UNITED STATES
DEPARTMENT OF THE INTERIOR
BUREAU OF LAND MANAGEMENTRECEIVED
OCD ArtesiaFORM APPROVED
OMB NO. 1004-0137
Expires: January 31, 2018**SUNDRY NOTICES AND REPORTS ON WELLS**
*Do not use this form for proposals to drill or to re-enter an abandoned well. Use form 3160-3 (APD) for such proposals.*5. Lease Serial No.
NMNM025503

☒ Oil Well ☐ Gas Well ☐ Other8. Well Name and No.
BENSON SHUGART 4

30-015-20567-00-S1

CHEVRON USA INC RESPECTFULLY REQUEST TO PLUG AN ABANDON THE ABOVE WELL AS FOLLOWS:

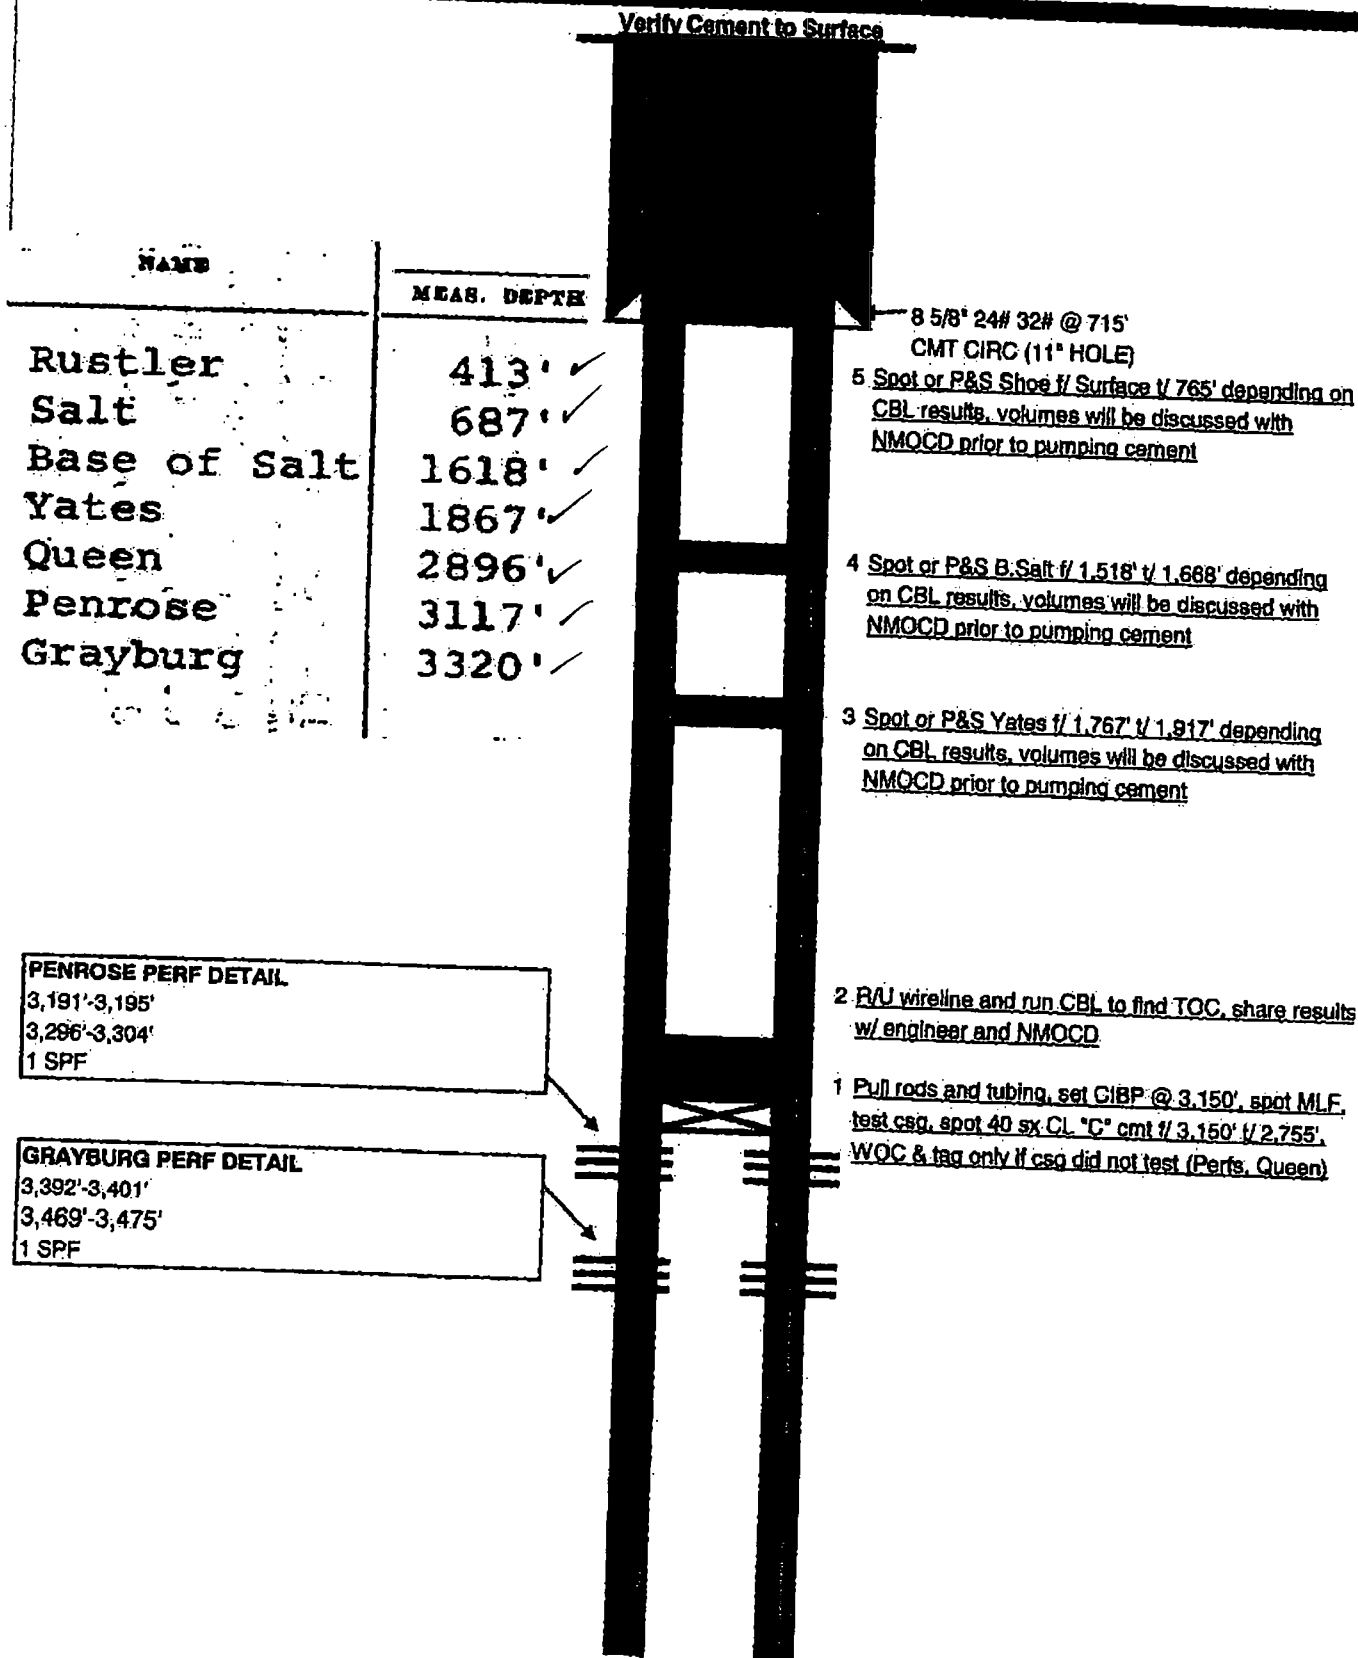
3. SET CIBP @3150'. SPOT MLF, TEST CASING, SPOT 40 SX CL "C" CMT F/3150' T/ 2755'. WOC AND TAG (PERFS, QUEEN)

4. R/U WIRELINE AND RUN CBL TO FIND TOC, SHARE RESULTS W/ENGINEER AND BLM.

5. SPOT OR P&S AT THE YATES F/1767' T/1917' DEPENDING ON CBL RESULTS, VOLUMES WILL BE DISCUSSED WITH BLM PRIOR TO PUMPING CEMENT.

6. SPOT OR P&S AT THE B SALT F/1518' T/1668' DEPENDING ON CBL RESULTS, VOLUMES WILL BE DISCUSSED WITH BLM PRIOR TO PUMPING CEMENT.

7. SPOT P&S AT THE SURFACE SHOE F/SURFACE T/765' PERF, DEPENDING ON CBL RESULTS, VOLUMES WILL BE DISCUSSED WITH BLM PRIOR TO PUMPING CEMENT.

8. CUT ALL CASINGS AND ANCHORS AND REMOVE 3' BELOW GRADE, VERIFY CEMENT TO SURFACE ON ALL CASING STRINGS AND WELD ON A DRY HOLE MARKER. CLEAN LOCATION.
NOTE ALL CEMENT PLUGS CLASS C WITH A CLOSED LOOP SYSTEM USE
PLEASE FIND ATTACHED A COPY OF A WELLBORE DIAGRAM.

** BLM REVISED ** BLM REVISED ** BLM REVISED ** BLM REVISED ** BLM REVISED **
